Piper Aircraft, Inc.
2926 Piper Drive
Vero Beach, FL, U.S.A. 32960

SERVICE NO. 1256 LETTER

Date: July 9, 2019

GASCOLATOR BRACKET ASSEMBLY INSPECTION

Figure 1
Gascolator Installation

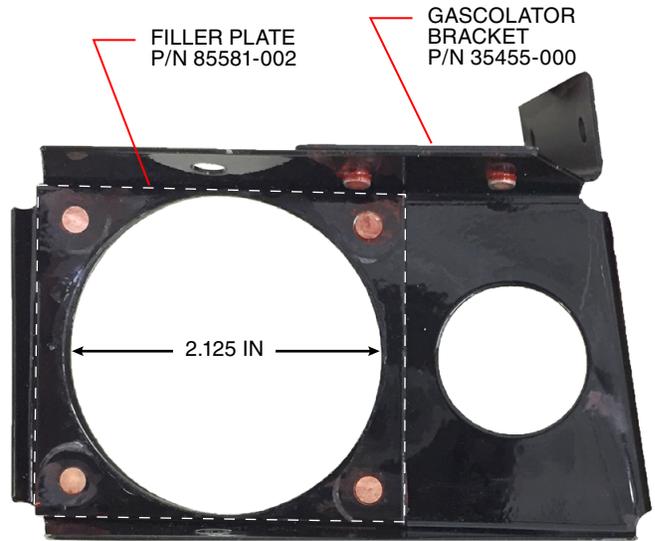
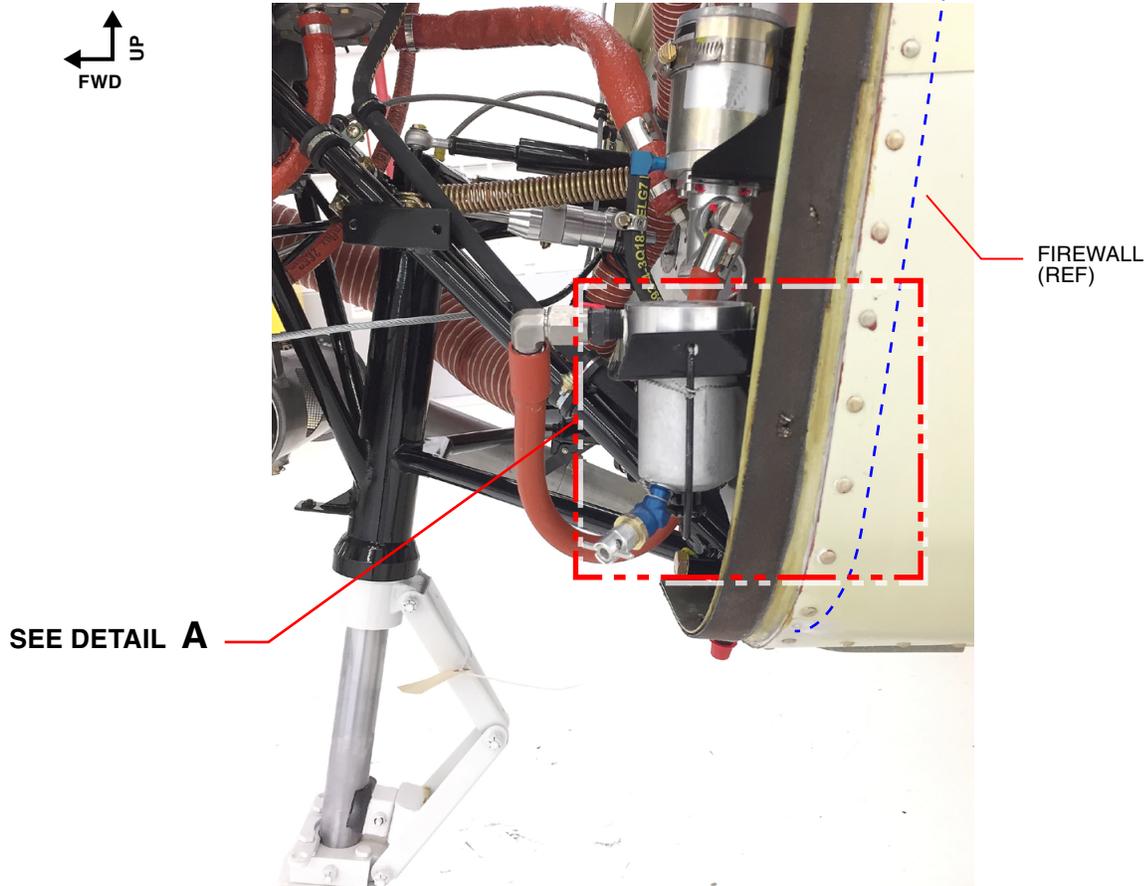
On some of the affected airplanes, there may not be enough clearance for the gascolator bowl (also known as the fuel strainer or fuel filter bowl) to be removed by lowering it through the gascolator bracket assembly. This lack of clearance would necessitate further disassembly, in order to remove the bowl upward.

If the bowl cannot be lowered, this service letter provides the steps to modify the hole in the filler plate, which is riveted to the gascolator bracket, to allow the proper removal of the bowl.

1. Follow the gascolator (aka the fuel strainer or fuel filter bowl) removal procedures in Section 28-20-00 of the appropriate Piper Airplane Maintenance Manual (AMM) or Section IX of the appropriate Piper Service Manual (SM). Also refer to Figure 1.
2. Measure the hole in Gascolator Filler Plate, Piper part number (P/N) 85581-002, which is riveted to the Gascolator Bracket, P/N 35455-000. The diameter of the hole should be 2.125 inches. See Figure 1, View B–B.
3. To modify the filler plate hole to 2.125 inches in diameter, complete the following steps:

- b. With a rotary tool, file or similar tool, carefully expand the hole in the Gascolator Filler Plate, P/N 85581-002, to a diameter of 2.125 +/- 0.010 inches.

- c. Remove any burrs or sharp edges from the modified hole. Wipe the surface of the bracket assembly using a soft cloth dampened with isopropyl alcohol, mineral spirits, naphtha, or other suitable cleaning agent.

- d. Apply primer to the areas where paint was removed using MIL-PRF-85582D primer, or any primer conforming to MIL-PRF-23377 and apply per manufacturer's instructions. Alternatively, Piper P/N 279-108 (AkzoNobel Aerospace Coatings P/N 10P30-5 / EC-275) may be used. Follow up with a coating of glossy or flat black enamel to match existing paint (such as Sherwin Williams F77B2 Flat Black or F77B1 Gloss Black).

- e. Check that the gascolator bowl can be inserted and removed from the modified bracket assembly.
 - f. Reinstall the Gascolator Bracket Assembly, P/N 35454-000.
